Access Audit Site Report

Lake Brownwood State Park
200 State Hwy Park Rd 15
Brownwood, TX 76801
Accessibility Evaluation
Inspection Date: 02/28/2022
Inspectors: Tanya Scheibe

Prepared By
WT Group

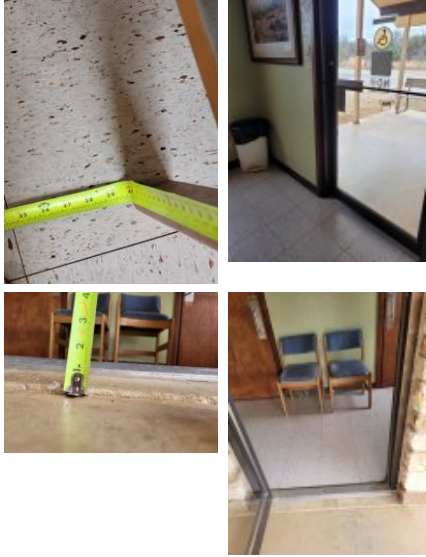
Finding Number	Area Description	Lat/Long	Finding	As Built	Recommendation	Citation	Photos	Figure
1	Headquarters (HQ) : HQ - Parking	[31.85596, -99.0161]	Element meets all standards and requirements	HQ - 14 standard stalls, 1 accessible stall; meets scoping requirements	None	2010 ADAS Section: N/A		
2	Headquarters (HQ) : HQ - Parking	[31.8569413, -99.0283979]	The access aisle is not a minimum 5 feet wide. A car accessible parking stall's access aisle must be a minimum of 5 feet wide measured from centerline to centerline. Where the access aisle is not adjacent to another parking space or access aisle, measurements shall be permitted to include the full width of the line defining the access aisle.	HQ parking - 4' 9" access aisle	Repaint access aisles to be 5' each	2015 ABAAS Section: 502.3.1 2012 TAS Section: 502.3.1 2010 ADAS Section: 502.3.1

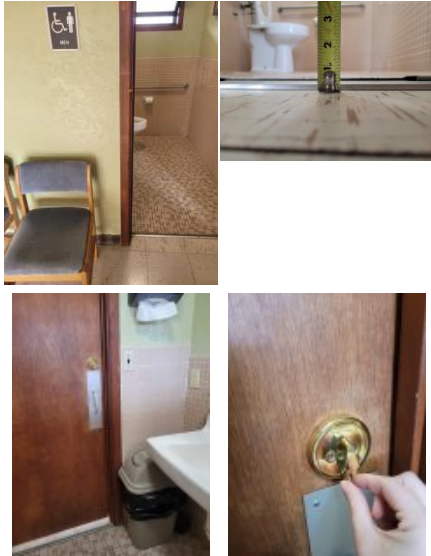
Finding Number	Area Description	Lat/Long	Finding	As Built	Recommendation	Citation	Photos	Figure
3	Headquarters (HQ) : HQ - Parking	[31.8569487 , -99.028397 9]	There are no van accessible parking stalls. 1 in every 6, minimum of one, required accessible stalls must be a van accessible stall. There are a total of 15 parking stalls in the parking lot that could be reasonably associated with this facility. There should be a minimum of 1 accessible stalls with a minimum of 1 being designed as van accessible.	HQ parking - lacks van stall	Add van parking sign to one accessible stall and repaint stall and access aisle to 11' and 5' or 8' and 8'.	2015 ABAAS Section: F208.2, F208.2.4 2012 TAS Section: 208.2, 208.2.4 2010 ADAS Section: 208.2, 208.2.4		
4	Headquarters (HQ) : HQ - Parking	[31.8569385 , -99.028369 8]	The cross slopes (narrow dimension) and/or running slopes (long dimension) of the access aisle exceeds 2%. The running slope and the cross slope in an accessible parking stall and the access aisle must not exceed 2%.	HQ parking - access aisle - 2.4% slope	Repair or correct slope of parking space and access aisle to max 2.08% in any direction.	2015 ABAAS Section: 502.4 2012 TAS Section: 502.4 2010 ADAS Section: 502.4

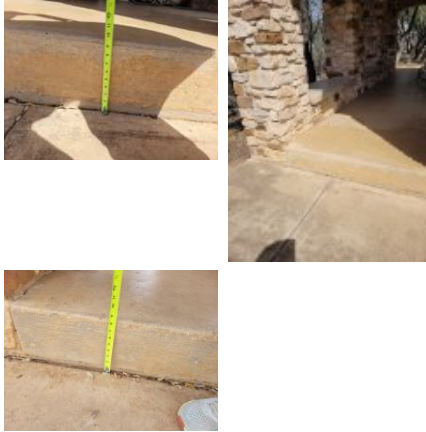
41	Park Site: Sports Fields/Courts	[31.857981 , -99.0173504]	At least one accessible route shall connect accessible buildings, accessible facilities, accessible elements, and accessible spaces that are on the same site. For areas of sport activity, an accessible route is required to connect to the boundary of each area of sport activity. The size of an area of sport activity includes only the space needed to play. Where multiple sports fields or courts are provided, an accessible route is required to each field or area of sport activity.	basketball lacks AR	Provide an accessible route to each element within the site.	2010 ADAS Section: 206.2.2, 206.2		
42	Park Site: Sports Fields/Courts	[31.8515892 , -99.0168309]	There is no accessible route to the volleyball court. At least one accessible route shall connect accessible buildings, accessible facilities, accessible elements, and accessible spaces that are on the same site.	no AR to volleyball court behind shelter 1 and 2	Create an accessible route with crushed stone or other outdoor material from parking or walkway to volleyball court.	2015 ABAAS Section: F206.2.2 2012 TAS Section: 206.2.2 2010 ADAS Section: 206.2.2

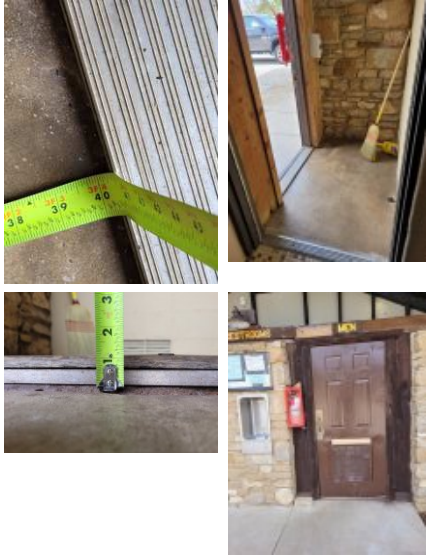
Finding Number	Area Description	Lat/Long	Finding	As Built	Recommendation	Citation	Photos	Figure
65	Council Bluff (CB) Area: CB - Parking	[31.85872, -99.0291825]	Element meets all standards and requirements	Council Bluff (CB) restroom building - 10 standard, 1 accessible; meets accessible stall count requirement	None	2010 ADAS Section: N/A		
66	Council Bluff (CB) Area: CB - Parking	[31.8587211, -99.02922]	The cross slopes (narrow dimension) and/or running slopes (long dimension) of the access aisle exceeds 2%. The running slope and the cross slope in an accessible parking stall and the access aisle must not exceed 2%.	CB restroom building, stall - 2.6% slope	Repair or correct slope of parking space and access aisle to max 2.08% in any direction.	2015 ABAAS Section: 502.4 2012 TAS Section: 502.4 2010 ADAS Section: 502.4		
67	Council Bluff (CB) Area: CB - Parking	[31.8587211, -99.0292294]	The parking stall contains abrupt edges and surface irregularities over a 1/4 inch vertical. Parking spaces and access aisles serving them shall be stable, firm, and slip resistant. Access aisles shall be at the same level as the parking spaces they serve. Changes in level are not permitted and shall not be sloped steeper than 2% in any direction.	CB restroom building - access aisle has sand within and needs repainted	Maintain stalls and access aisles to be free of debris. Repaint stalls and access aisles where faded.	2015 ABAAS Section: 502.4 2012 TAS Section: 502.4 2010 ADAS Section: 502.4

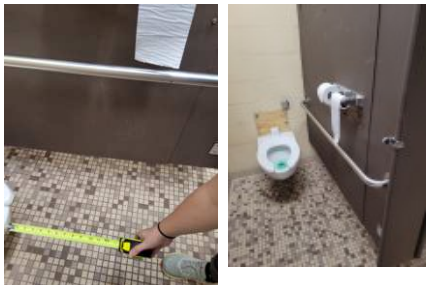
Finding Number	Area Description	Lat/Long	Finding	As Built	Recommendation	Citation	Photos	Figure
76	Council Bluff (CB) Area: CB - Men's Restroom	[31.8586323 , -99.029194 5]	The bench is not deep enough or long enough or is missing. Benches shall be provided having seats that are 42 inches long minimum and 20 inches deep minimum and 24 inches deep maximum. The bench shall provide for back support or shall be affixed to a wall. Back support shall be 42 inches (1065 mm) long minimum and shall extend from a point 2 inches (51 mm) maximum above the seat surface to a point 18 inches (455 mm) minimum above the seat surface. Back support shall be 2½ inches (64 mm) maximum from the rear edge of the seat measured horizontally. The top of the bench seat surface shall be 17 inches (430 mm) minimum and 19 inches (485 mm) maximum above the finish floor or ground. Clear floor or ground space complying with 305 shall be provided and shall be positioned at the end of the bench seat and parallel to the short axis of the bench	13.5" by 36", non compliant corner bench	Replace bench in dressing area with one having a seat depth of 20" to 24" deep, 42" long, affixed to the wall or having a back and mounted 17" to 19" aff and provide required clear floor space on the short axis of the bench.	2012 TAS Section: 903.4, 903.2, 903.3, 903.5 2010 ADAS Section: 903.4, 903.2, 903.3, 903.5

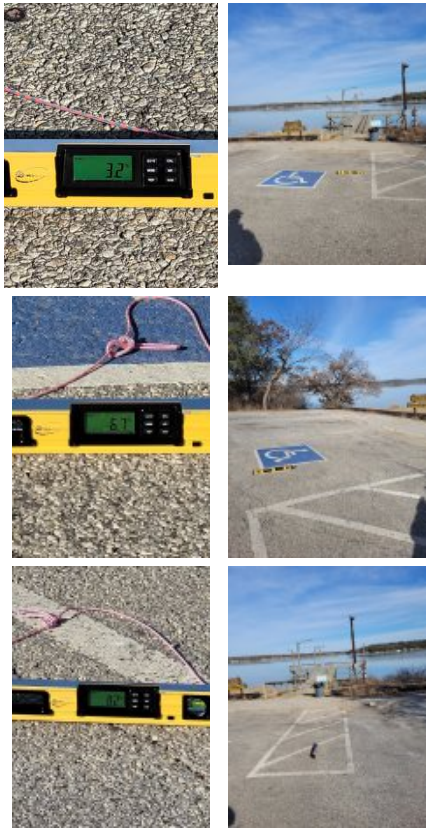
Finding Number	Area Description	Lat/Long	Finding	As Built	Recommendation	Citation	Photos	Figure
106	Willow Point (WP) Area: WP - Parking	[31.8618484 , -99.025743 9]	Element meets all standards and requirements	Willow Point (WP) restroom building by site 10 - 4 standard, 1 accessible; meets scoping requirements	None	2010 ADAS Section: N/A		
107	Willow Point (WP) Area: WP - Parking	[31.861841, -99.025745 2]	The cross slopes (narrow dimension) and/or running slopes (long dimension) of the access aisle exceeds 2%. The running slope and the cross slope in an accessible parking stall and the access aisle must not exceed 2%.	WP restroom building by site 10, stall - 3% slope, 3.3% slope. access aisle - 7.9% slope, 5.9% slope	Repair or correct slope of parking space and access aisle to max 2.08% in any direction.	2015 ABAAS Section: 502.4 2012 TAS Section: 502.4 2010 ADAS Section: 502.4

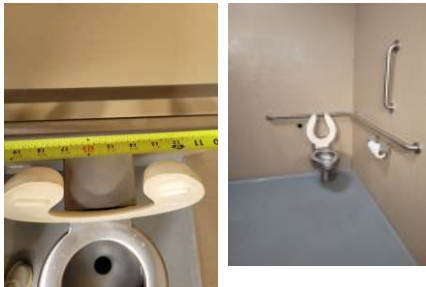
Finding Number	Area Description	Lat/Long	Finding	As Built	Recommendation	Citation	Photos	Figure
123	Willow Point (WP) Area: WP - Exterior Accessible Route	[31.8629538 , -99.024377 3]	There is a gap spaced greater than a 1/2 inch. Openings in floor or ground surfaces shall not allow passage of a sphere more than 1/2 inch diameter. Elongated openings shall be placed so that the long dimension is perpendicular to the dominant direction of travel.	1" gap at WP restroom building by site 20 to women's, 1" gap parallel to fire extinguisher at same building, 1.25" gap outside of women's restroom door. path to men's - 1.5" gap	Correct or fill gaps to be max .5"	2015 ABAAS Section: 302.3 2012 TAS Section: 302.3 2010 ADAS Section: 302.3

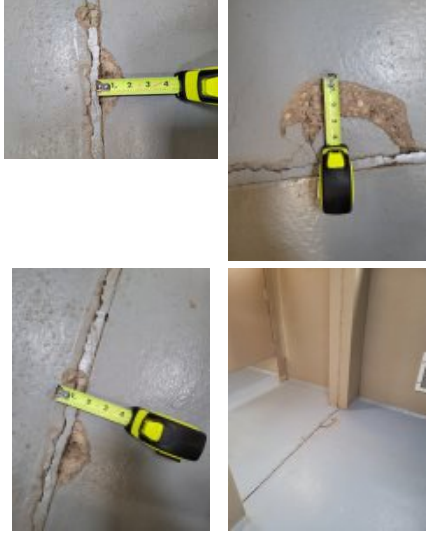
Finding Number	Area Description	Lat/Long	Finding	As Built	Recommendation	Citation	Photos	Figure
124	Willow Point (WP) Area: WP - Exterior Accessible Route	[31.8629789 , -99.024412 2]	The accessible route of travel contains cross slopes greater than 2%. Cross slopes shall not exceed one unit vertical in 48 units horizontal (2-percent slope).	3.5% cross slope along parking pathway at WP restroom building by site 20	Correct or repair cross slope along AR to max 2.08%.	2015 ABAAS Section: 403.3 2012 TAS Section: 403.3 2010 ADAS Section: 403.3		
125	Willow Point (WP) Area: WP - Exterior Accessible Route	[31.8629538 , -99.024331 7]	The running slope of walking surfaces shall not be steeper than 1:20.	8% slope at restroom by site 20 in WP area	Correct running slope along the AR to max 5%	2015 ABAAS Section: 403.3 2012 TAS Section: 403.3 2010 ADAS Section: 403.3		
126	Willow Point (WP) Area: WP - Exterior Accessible Route	[31.8628835 , -99.024418 1]	There is a gap spaced greater than a 1/2 inch. Openings in floor or ground surfaces shall not allow passage of a sphere more than 1/2 inch diameter. Elongated openings shall be placed so that the long dimension is perpendicular to the dominant direction of travel.	1.5" gap at Willow Point women's restroom entry, 1" gap in front of access aisle to pathway at Willow Point restroom building	Correct or fill gaps to be max .5"	2015 ABAAS Section: 302.3 2012 TAS Section: 302.3 2010 ADAS Section: 302.3

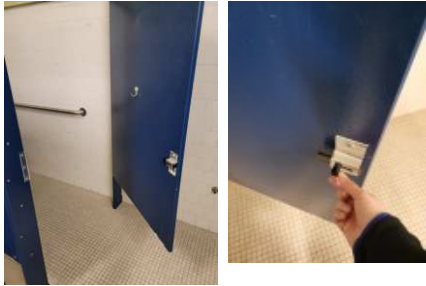
Finding Number	Area Description	Lat/Long	Finding	As Built	Recommendation	Citation	Photos	Figure
164	Willow Point (WP) Area: WP - Women's Restroom (near site 20)	[31.8629242 , -99.024436 3]	Shower controls are in the incorrect location In transfer type shower compartments, the controls, faucets, and shower spray unit shall be installed on the side wall opposite the seat 38 inches (965 mm) minimum and 48 inches (1220 mm) maximum above the shower floor and shall be located on the control wall 15 inches (380 mm) maximum from the centerline of the seat toward the shower opening.	controls on wrong wall	Remount shower controls to the correct location in the transfer shower	2015 ABAAS Section: 608.5.1 2012 TAS Section: 608.5.1 2010 ADAS Section: 608.5.1		
165	Willow Point (WP) Area: WP - Women's Restroom (near site 20)	[31.8629219 , -99.024433 6]	There is no hand held sprayer unit. The sprayer unit must have a 59 inches hose and be mounted 48 inches maximum to the top of mounting bracket off the floor. The shower spray unit shall have an on/off control with a non-positive shutoff. If an adjustable-height shower head on a vertical bar is used, the bar shall be installed so as not to obstruct the use of grab bars.	lacks hose, head is 65" AFF	Replace shower control with a compliant lever control with a shower head on a 59" hose and usable as hand held.	2015 ABAAS Section: 608.6 2012 TAS Section: 608.6 2010 ADAS Section: 608.6	 	SHOWER SPRAY UNIT  Water Temperature: 120° F Max. Top of mounting bracket: 48" Max. above the shower floor. <small>©Builder's Book, Inc.</small>

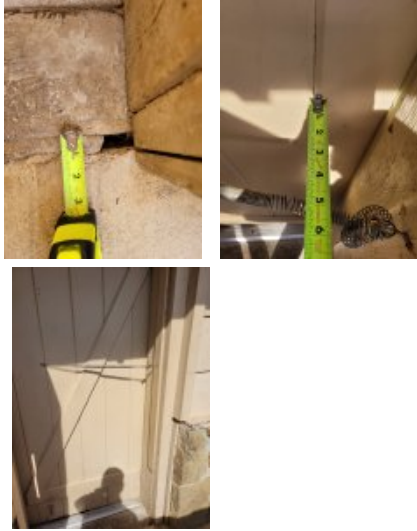
Finding Number	Area Description	Lat/Long	Finding	As Built	Recommendation	Citation	Photos	Figure
169	Willow Point (WP) Area: WP - Women's Restroom (near site 20)	[31.8629106 , -99.024444 4]	There are not enough accessible toilet compartments. The room contains toilet compartments. A minimum of 1 must be wheelchair accessible .	1 ambulatory stall, 2 standard stalls	Create a wheelchair accessible stall with grab bars and fixtures mounted in correct locations and at correct heights.	2015 ABAAS Section: F213.3.1 2012 TAS Section: 213.3.1 2010 ADAS Section: 213.3.1		
170	Willow Point (WP) Area: WP - Women's Restroom (near site 20)	[31.8629288 , -99.024455 1]	The ambulatory stall is not between 35" to 37" wide and 60" deep.	ambulatory stall 43" wide	Correct ambulatory stall to be 35" to 37" wide and minimum 60" deep.	2015 ABAAS Section: 604.8.2.1 2012 TAS Section: 604.8.2.1 2010 ADAS Section: 604.8.2.1

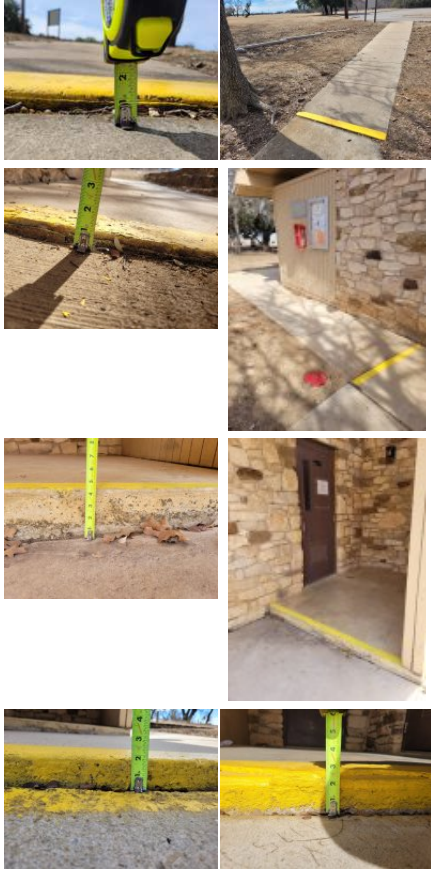
Finding Number	Area Description	Lat/Long	Finding	As Built	Recommendation	Citation	Photos	Figure
196	Day Use Restroom Buildings : Day Use - Parking (by dining hall restrooms)	[31.8616724 , -99.022167 2]	Element meets all standards and requirements	Day Use by Dining Hall - 47 standard 2 accessible; meets stall count requirement	None	2010 ADAS Section: N/A		
197	Day Use Restroom Buildings : Day Use - Parking (by dining hall restrooms)	[31.8617169 , -99.022099 4]	The parking sign is mounted too low. Parking space identification signs shall include the International Symbol of Accessibility complying with. Signs identifying van parking spaces shall contain the designation "van accessible." Signs shall be 60 inches minimum above the finish floor or ground surface measured to the bottom of the sign.	Day Use by Dining Hall, stall closer to WP - 51" above ground level (agl)	Raise existing accessible parking signs so lowest end of bottom sign is min 60" above ground level (AGL) measured from the surface of the stall.	2015 ABAAS Section: 502.6 2012 TAS Section: 502.6 2010 ADAS Section: 502.6

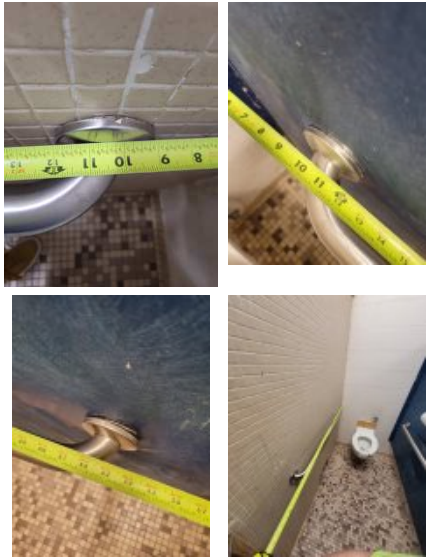
Finding Number	Area Description	Lat/Long	Finding	As Built	Recommendation	Citation	Photos	Figure
286	Comanche Trails (CT) Area: CT - Parking	[31.8512918 , -99.0173043]	There are no or not enough accessible parking stalls. Each lot where parking is provided for the public as clients, guests or employees, shall provide accessible parking and shall be located on the shortest accessible route of travel from adjacent parking to an accessible entrance. There are a total of 13 parking stalls in the parking lot that could be reasonably associated with this facility. There should be a minimum of 1 accessible stalls with a minimum of 1 being designed as van accessible.	0 of 13 parking spaces by shelters 1 and 2 are accessible	Create one or more 8' accessible parking stalls, with one 5' adjacent access aisle, with proper signage and striping based on the total number of stalls.	2015 ABAAS Section: F208.2 2012 TAS Section: 208.2 2010 ADAS Section: 208.2

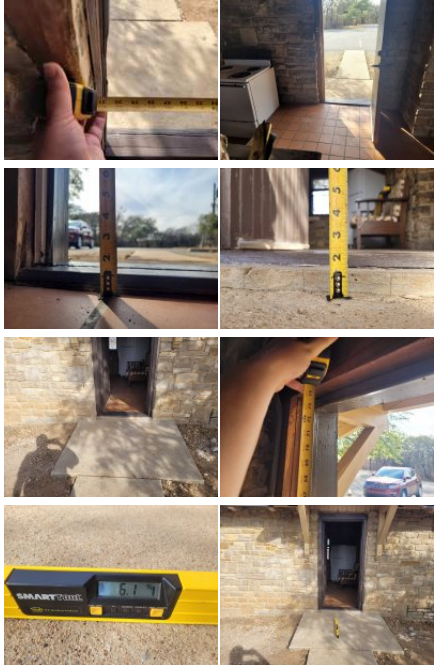
Finding Number	Area Description	Lat/Long	Finding	As Built	Recommendation	Citation	Photos	Figure
331	Comanche Trails (CT) Area: CT - Sample Shelter Campsite	[31.85177, -99.01719]	48 inches (1220 mm) by 48 inches (1220 mm) on all usable sides of the fire ring, grill, fireplace, and woodstove Center the space on each usable side of the grill, fireplace, and woodstove	shelter 1 - fire ring lacks clear floor space	Provide required 48" clear ground space centered along usable side of fire ring, grill, fireplace, or woodstove as a smart practice	2015 ABAAS Section: 1011.2		
332	Comanche Trails (CT) Area: CT - Sample Shelter Campsite	[31.85177, -99.01719]	Fire building surfaces shall be 9 inches (230 mm) minimum above the ground	shelter 1 - fire surface at ground	Correct fire building surface to be 9" min above the ground as a smart practice.	2015 ABAAS Section: 1011.5.1		
333	Comanche Trails (CT) Area: CT - Sample Shelter Campsite	[31.851811, -99.0171659]	Where provided, cooking surfaces shall be 15 inches (380 mm) minimum and 34 inches (865 mm) maximum above the ground	shelter 1 - grill 36" AFF at lowest	Raise or lower cooking surface to be 15" min to 34" max above the ground; in the alternative, replace with a compliant surface as a smart practice	2015 ABAAS Section: 1011.5.2

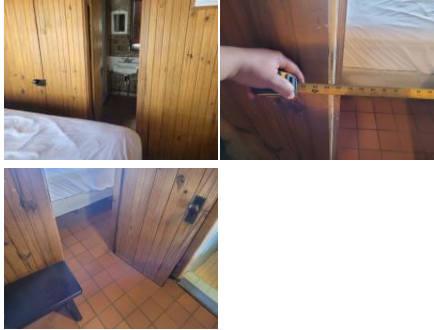
Finding Number	Area Description	Lat/Long	Finding	As Built	Recommendation	Citation	Photos	Figure
335	Comanche Trails (CT) Area: CT - Sample Shelter Campsite	[31.8518008 , -99.017206 1]	Water spouts at water hydrants and water utility hook-ups shall be 28 inches (710 mm) minimum and 36 inches (915 mm) maximum above the ground	shelter 1 - spout 25"	Remount water spouts to 28" min or 36" max above the ground as a smart practice	2015 ABAAS Section: 1011.6		
336	Comanche Trails (CT) Area: CT - Sample Shelter Campsite	[31.8518065 , -99.017251 7]	Camping facilities shall provide camping units with mobility features complying with F244.2 in accordance with Table F244.2. Where a camping facility provides different types of camping units, Table F244.2 shall apply to each type of camping unit provided. Total Number of Camping Units Provided in Camping Facility Minimum Number of Camping Units with Mobility Features Required 1 1 2 to 25 2 26 to 50 3 51 to 75 4 76 to 100 5 101 to 150 7 151 to 200 8 201 and over 8, plus 2 percent of the number over 200	0 of 10 shelters accessible at time of audit	Create the required number of accessible camp sites per table F244.2 as a smart practice	2015 ABAAS Section: F244.2

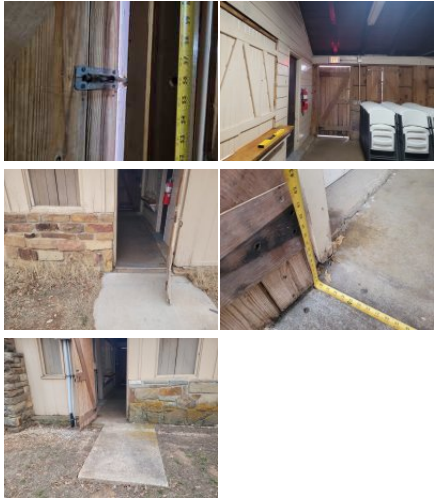
Finding Number	Area Description	Lat/Long	Finding	As Built	Recommendation	Citation	Photos	Figure
380	Group Dining Hall : Dining Hall - Public Spaces	[31.8617738 , -99.0221645]	The operable part is not accessible because it requires tight grasping, pinching or twisting of the wrist.	dining- knobs for heaters removed, require pinch	Replace operable part with one usable without a tight pinch or grasp	2015 ABAAS Section: 309.4 2012 TAS Section: 309.4 2010 ADAS Section: 309.4		
381	Group Dining Hall : Dining Hall - Public Spaces	[31.8617692 , -99.0221511]	The top rim of the sink is too high. All lavatories/sinks that are designated to be accessible shall be a minimum 17 inches in horizontal depth and mounted with the rim or counter edge no higher than 34 inches above the finished floor.	kitchen- sink rim 38"	Lower sinks to max 34" above the finished floor (AFF) to front of rim.	2015 ABAAS Section: 606.3 2012 TAS Section: 606.3 2010 ADAS Section: 606.3

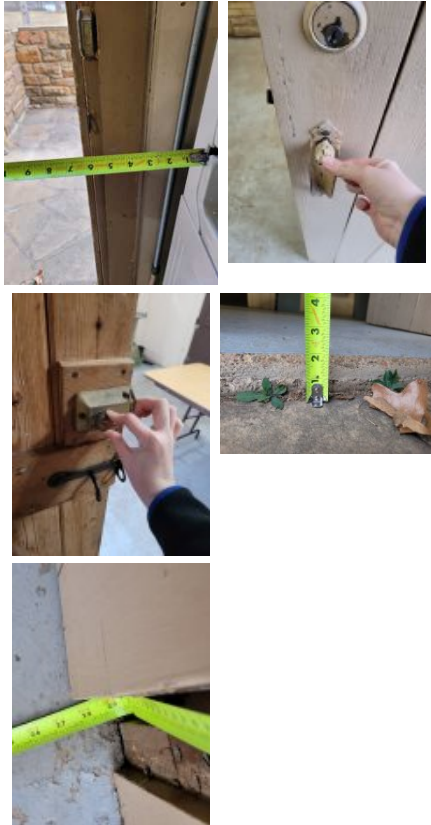
Finding Number	Area Description	Lat/Long	Finding	As Built	Recommendation	Citation	Photos	Figure
384	Group Dining Hall : Dining Hall - Public Spaces	[31.8617556 , -99.0221886]	Knee and toe space has not been provided at the sink. Kitchen sinks must be provided with a clear floor space positioned for a forward approach including knee and toe clearance.	kitchen- deep bowl sink and supports prevent knee clearance	Replace sink with one that provides knee and toe clearance	2015 ABAAS Section: 606.2, 804.4 2012 TAS Section: 606.2, 804.4 2010 ADAS Section: 606.2, 804.4		
385	Group Dining Hall : Dining Hall - Public Spaces	[31.8617601 , -99.0221537]	An item or items project more than 4 inches into the circulation path. Wall-mounted objects that have leading edges between 27 inches and 80 inches from the floor must not project more than 4 inches into the circulation path. Protruding objects that extend to the floor or within 27 inches of the floor are cane detectable and are therefore not hazardous. Where it is necessary or desirable to have objects protrude from the wall, a manner of cane detection must be provided.	kitchen- counter projects 8.75"	Relocate protruding objects or place cane detectable warning or bollard at foot of item	2015 ABAAS Section: 307.2 2012 TAS Section: 307.2 2010 ADAS Section: 307.2

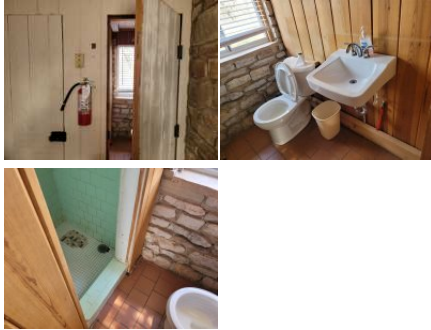
Finding Number	Area Description	Lat/Long	Finding	As Built	Recommendation	Citation	Photos	Figure
439	Oak Lodge: Oak Lodge - Public Space	[31.859545, -99.0181895]	The required clear space on both sides of the bed has not been provided. Accessible sleeping rooms shall have a 30 inch minimum by 48 inch minimum clear width space located along both sides of a bed.	living/dining/bedroom- lacks CFS on one side of bed	Provide CFS on both sides of a single bed	2015 ABAAS Section: 806.2.3 2012 TAS Section: 806.2.3 2010 ADAS Section: 806.2.3		
440	Oak Lodge: Oak Lodge - Public Space	[31.8595225, -99.0182032]	The required clear space on both sides of the bed has not been provided. Accessible sleeping rooms shall have a 30 inch minimum by 48 inch minimum clear width space located along both sides of a bed.	bedroom- lacks CFS on one side of bed	provide CFS on both sides of a single bed	2015 ABAAS Section: 806.2.3 2012 TAS Section: 806.2.3 2010 ADAS Section: 806.2.3
